LIMERICK GENERATING STATION
PROBABILISTIC RISK ASSESSMENT
REVISION 4 PAGE CHANGES

PROBABILISTIC RISK ASSESSMENT
LIMERICK GENERATING STATION
PHILADELPHIA ELECTRIC COMPANY

DOCKET NOS. 50-352
50-353

Figure 3.4.14 Containment Event Tree for the Mark II Containment

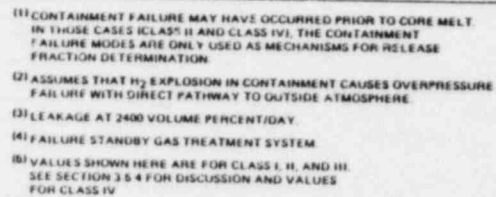
The containment event tree assumes an equal probability of containment failure occurring in the wetwell or drywell. Interpretation of the information in Appendix J, and the information presented at the February meeting results in our assumption that the containment failure always starts at the midwall of the wetwell and rapidly progresses upward to the drywell. Thus, both the wetwell and drywell will be failed simultaneously. This would remove the distinction of whether or not the failure was in the drywell or wetwell and whether or not the suppression pool has been lost, i.e., all failures rapidly lead to drywell failure and loss of the suppression pool scrubbing is irrelevant. What is the rationale for using the containment event tree sequences as presented in Figure 3.4.14?

Figure 3.5.6a Containment Event Tree for the Mark II Containment for Class I, II, and III Event Sequences

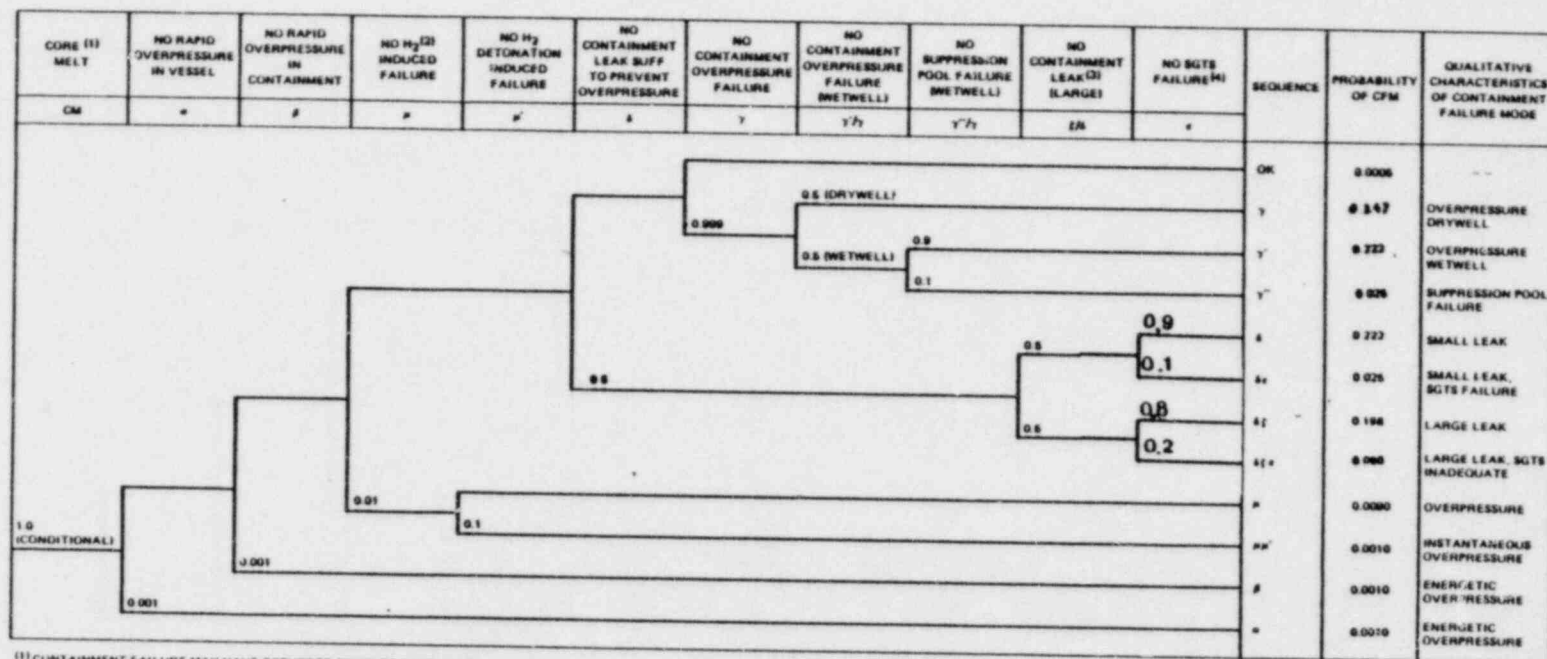
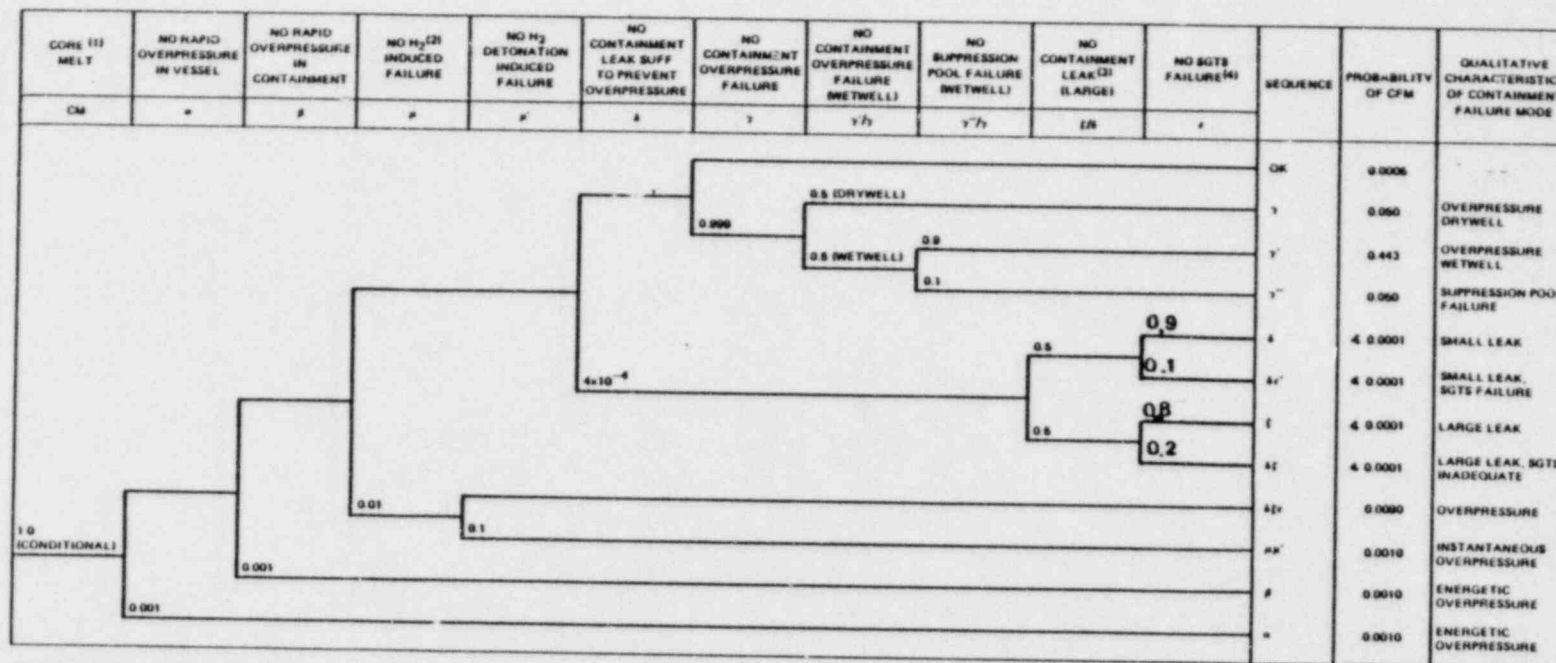
What are the bases for the selection of the probabilities on the containment event tree? Address each containment failure mode in detail.

The containment event tree for Class I, II, and III is Figure 3.5.6a on p. 3-114 of Revision 3 to the PRA. The Class IV CET is Figure 3.5.6b on p. 3-115. These figures contain numerical errors as submitted in Revision 3. Corrected figures are included. Conditional probabilities as utilized in the Limerick containment event trees (CET) were developed utilizing:

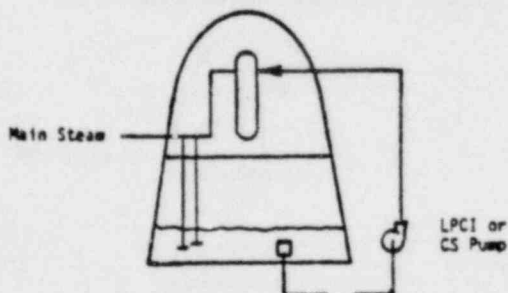
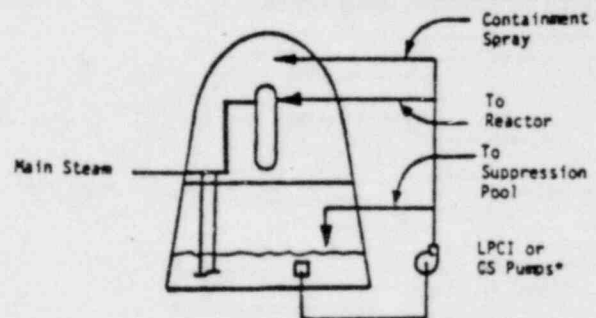
The text indicates (p. 3-43) that the success criteria and calculated probability of long term coolant recirculation and short term coolant injection are similar. Why are the success criteria for long term and short term demands the same? What is the difference in system configuration between coolant injection and coolant recirculation?

Given the long time nature of some of the accident scenarios--in the order of twenty to thirty hours, was failure subsequent to successful system actuation addressed in the Limerick study (failure to run)? If yes, were the degraded environmental conditions under which the systems must operate taken into consideration?

COOLANT INJECTION AND
ONE MODE OF THE COOLANT
RECIRCULATION

COOLANT RECIRCULATION

It should be noted that the coolant recirculation function is a carryover from the WASH-1400 PWR terminology and is not a BWR system or function.

- (c) Failure of coolant injection/recirculation functions over the period 0-20 hours is included in the evaluation of the conditional probabilities of component failure. In this way the failure of components to run are included in the quantification. It must be noted that the dominant contributors to the calculated conditional probability of system failure are demand failures.

FIGURE 1

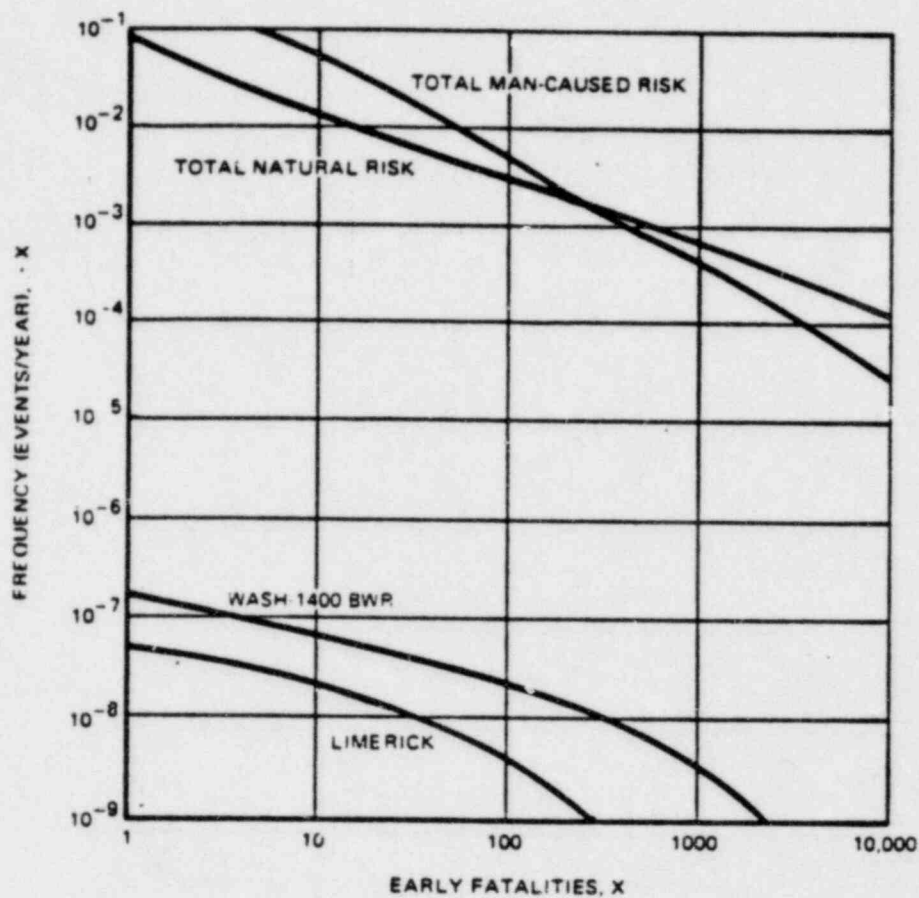
Explain in detail how Figure 4.3 was generated. What exactly was used to compute the risk of Limerick at WASH-1400 composite site with WASH-1400 data methods?

STEP 1: Figure 1 (attached) was constructed. This Figure 4.4 in Revision 3 to the PRA.

FIGURE 2

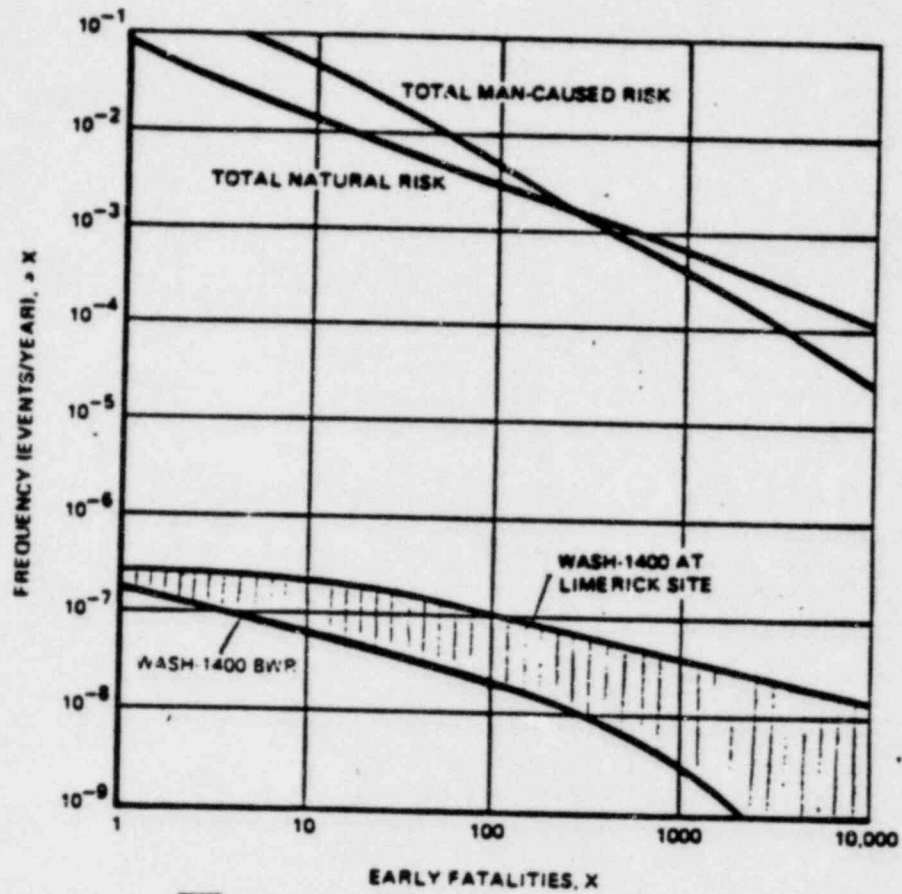
STEP 2: Figure 2 (attached) was constructed. This is Figure 4.1 in Revision 3 of the PRA.

In this figure, the lower curve is repeated from Figure 1, and again represents the WASH-1400 BWR, as published.

FIGURE 3

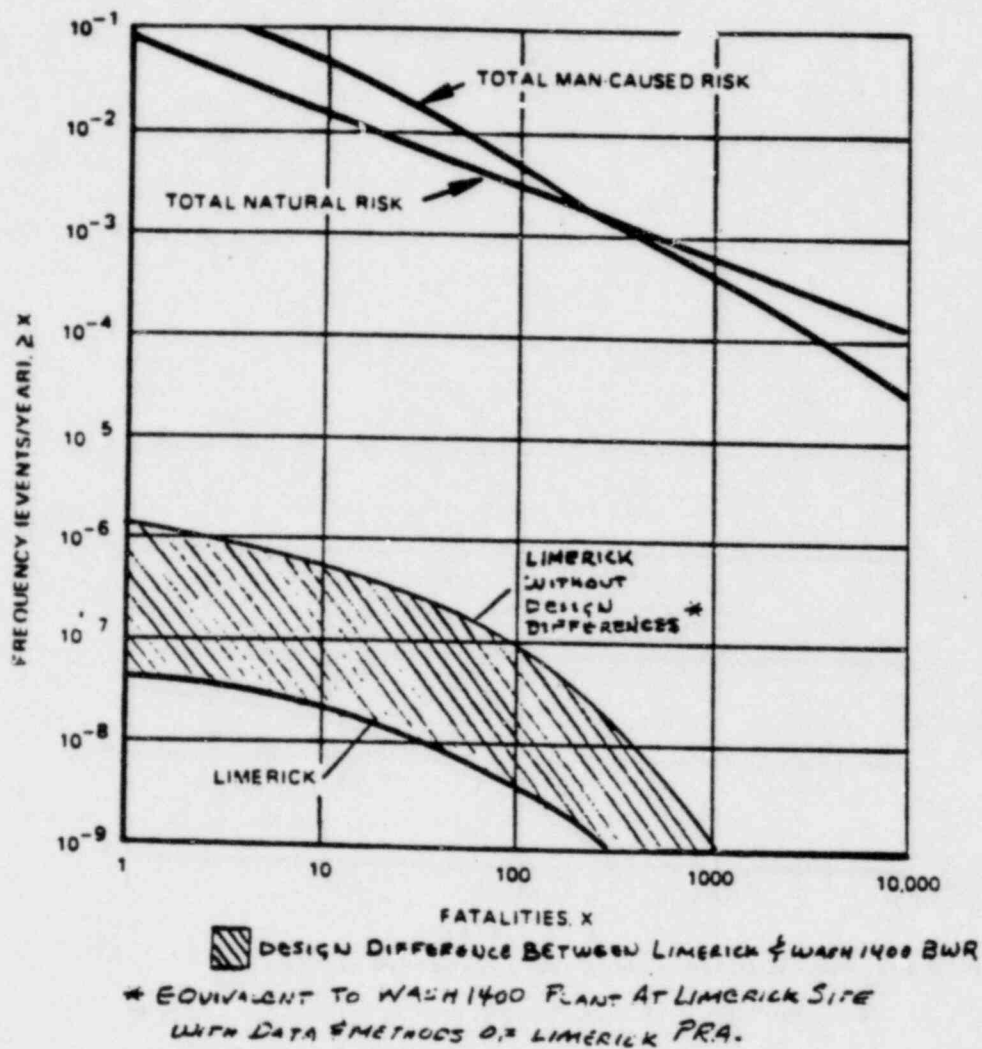
STEP 3: Figure 3 (attached) was constructed. This figure is not included in the Limerick PRA report.

In this figure, the lower curve is the Limerick CCDF repeated from Figure 1.

FIGURE 4

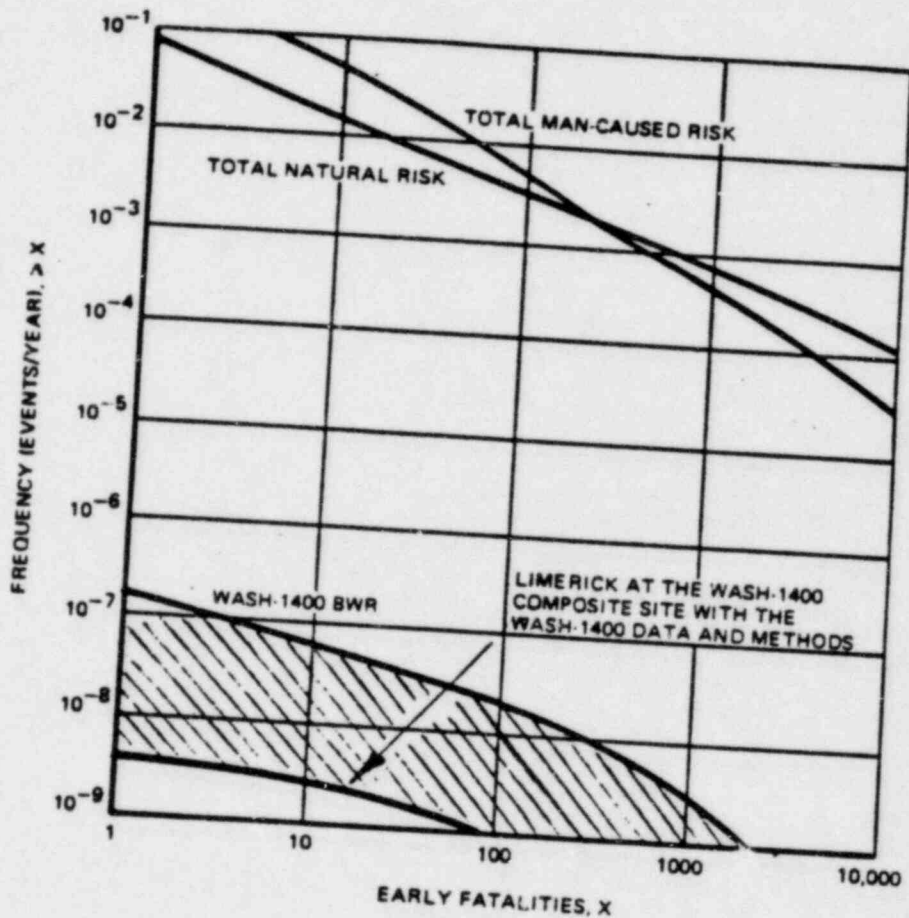
STEP 4: Figure 4 (attached) was constructed. This is Figure 4.3 in Revision 3 to the PRA.

This figure was constructed only to allow direct comparison to the WASH-1400 CCDF. In the figure, the upper curve is the WASH-1400 CCDF repeated from Figure 1.

The lower curve was not generated directly from a CRAC run. It was generated by applying the difference between the two curves on Figure 3 to the WASH-1400 CCDF, by ratio. Points on the lower curve of Figure 4 have the same ratio to the upper curve as the ratio between the lower and upper curves on Figure 3.

FIGURE 5

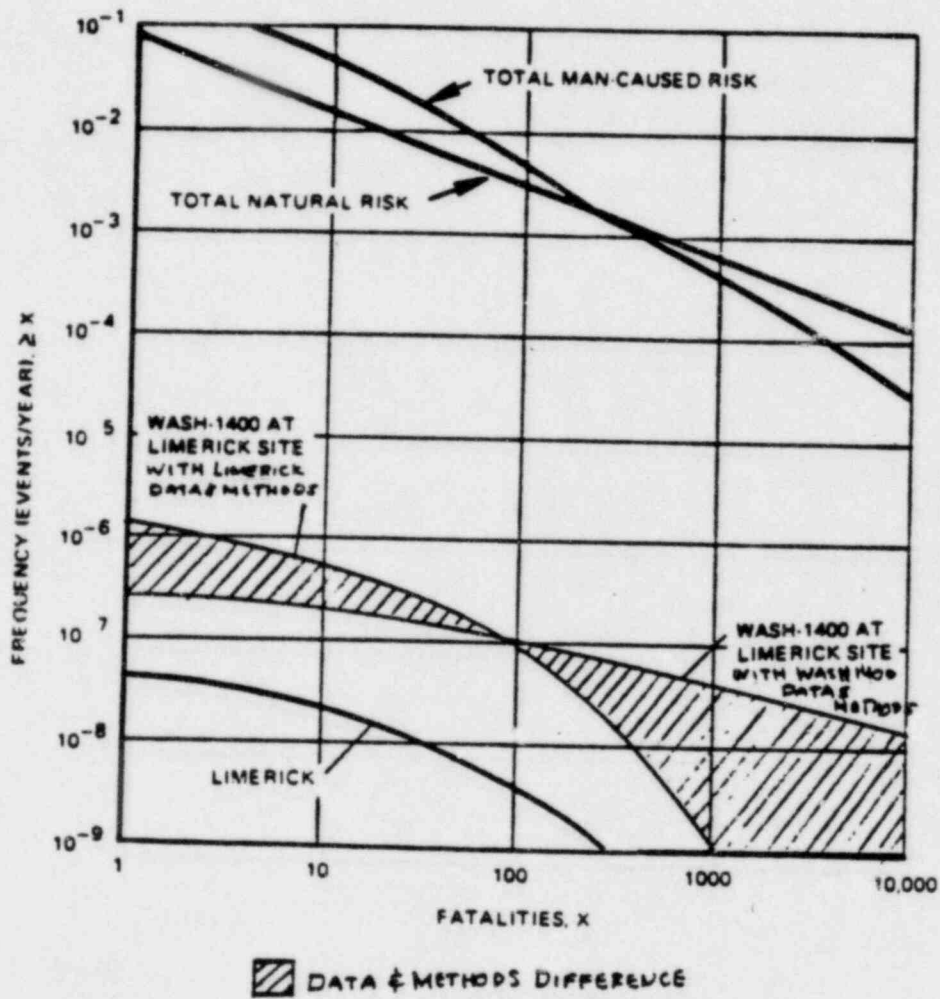
STEP 5: Figure 5 (attached) was constructed. This figure is not included in the PRA report.

This figure was constructed to provide a comparison between the effect of the data and methods used in the Limerick analysis and the data and methods used in the WASH-1400 analysis. In this figure, the curve that is lower on the left represents the WASH-1400 BWR at the Limerick site using WASH-1400 data and methods. This curve is repeated from Figure 2.

The curve that is uppermost on the left represents the WASH-1400 BWR at the Limerick site with Limerick data and methods. This curve is repeated from Figure 3.

FIGURE 6

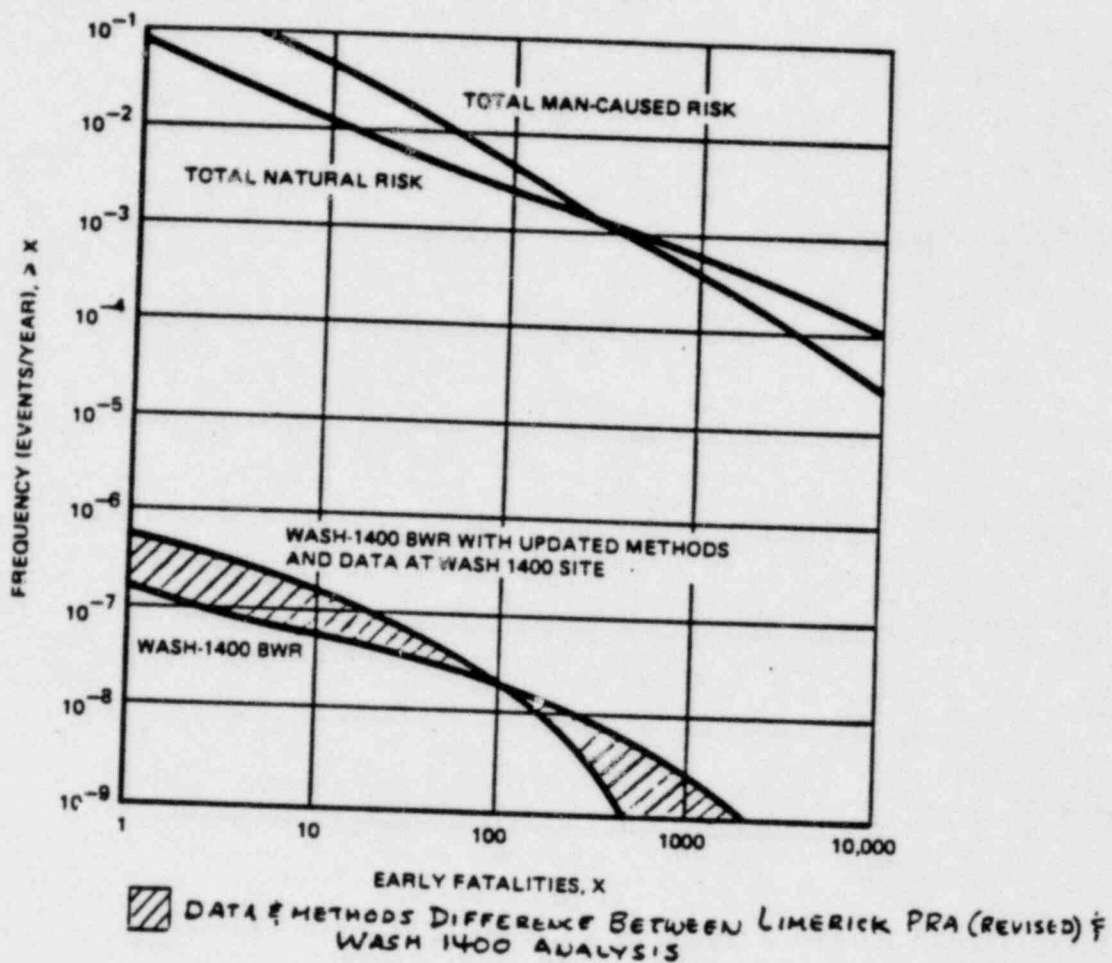
How was Figure 4.2 "WASH-1400 BWR with updated methods and data" obtained?

STEP 6: Figure 6 (attached) was constructed. This is Figure 4.2 in Revision 3 to the PRA.

This figure was constructed only to allow direct comparison to the WASH-1400 CCDF. The curve that is lower on the left is the WASH-1400 CCDF repeated from Figure 1.

The curve that is uppermost on the left represents the WASH-1400 BWR at the WASH-1400 site with the data and methods used in the Limerick analysis. This curve was not generated directly from a CRAC run. It was generated by applying the difference between the two curves of Figure 5 to the WASH-1400 CCDF, by ratio. Points on this curve have the same ratio to the WASH-1400 CCDF as the ratio between the two curves on Figure 5.

The only difference between the two curves is the effect of differences in data and methods. As shown on Figure 5, the methods and data used in the Limerick analysis produce a somewhat higher CCDF at lower consequences and a somewhat lower CCDF at high consequences.
